Additional thoughts

Additional thoughts since presentation was prepared

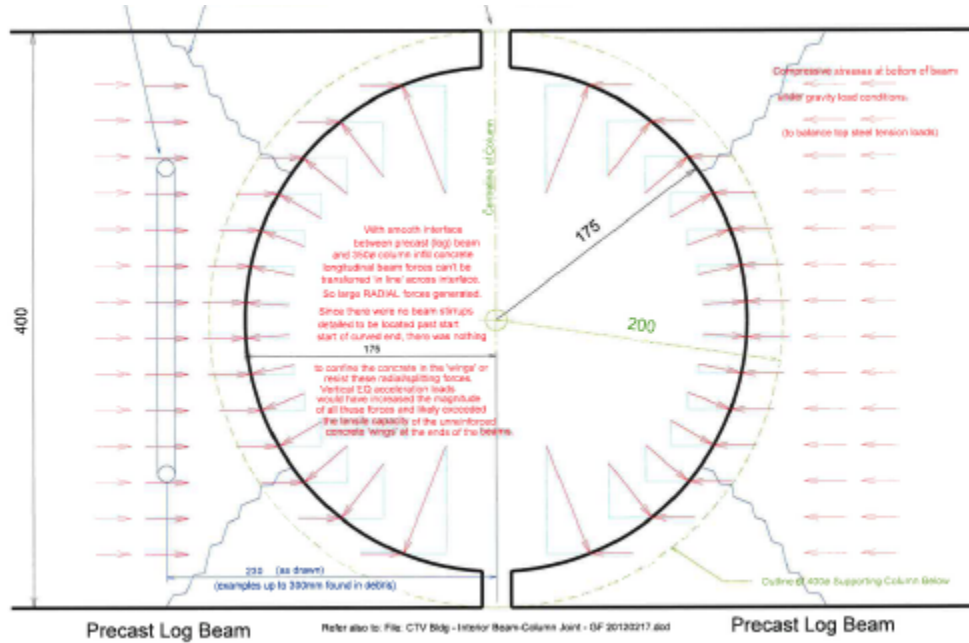
- I want to emphasize that the report discussion of the diaphragm tension failure planes shown below is strong: That is, on the upper floors, that the tension failure plane observed in the field is not the weakest and therefore not likely. However, this does not rule out partial disconnection.

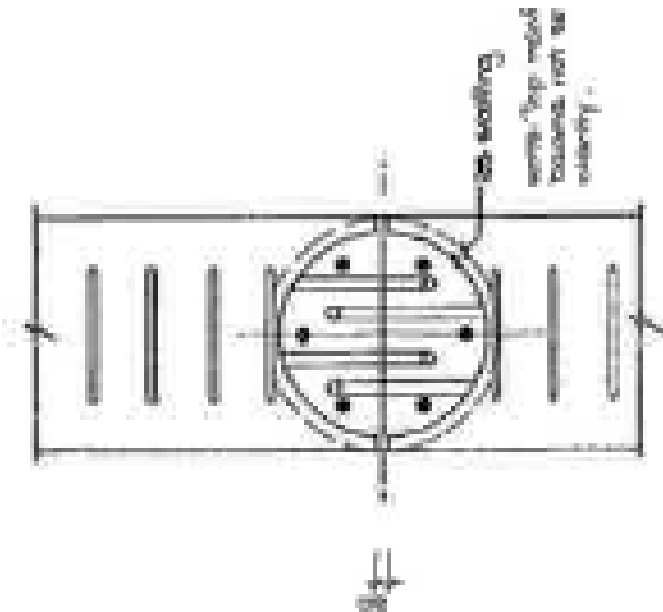
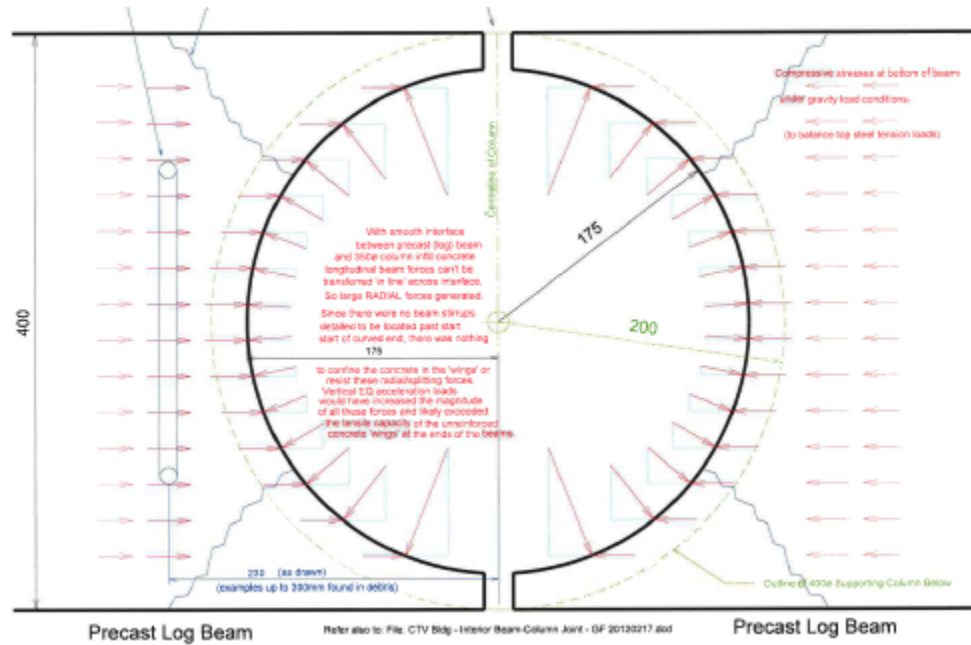
- There has still been very little discussion about the light damage observed in the North Tower. Could the drifts proposed to cause failure in some columns occurred without causing damage to the tower (without disconnection)? 1%-1.5% story drift (which affected columns) is large for the NS oriented walls of the tower.

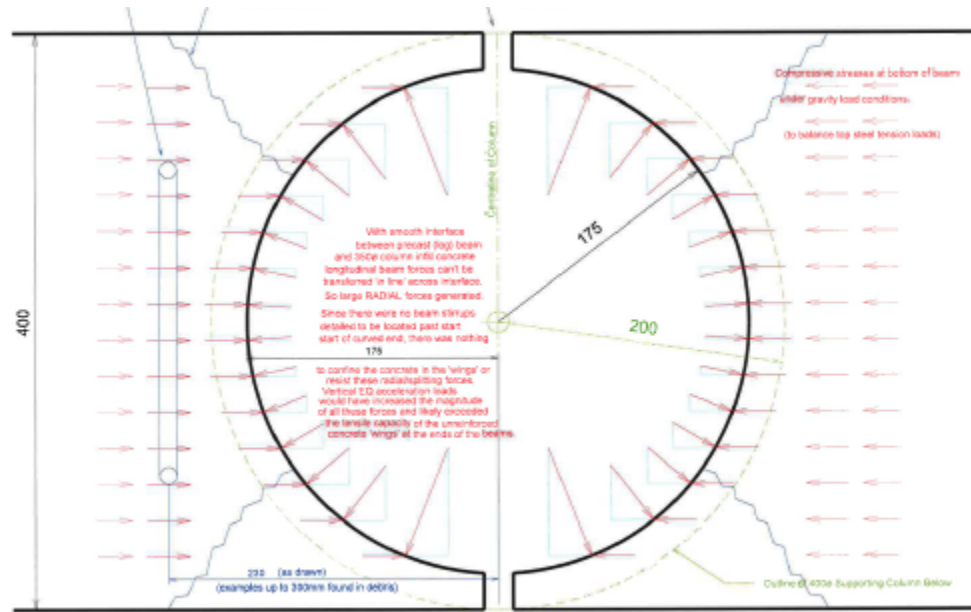
- It is not clear to me exactly how engineers at the time would have implemented the requirements for “Limited Ductility” so it is difficult to speculate on whether such a structure would have survived
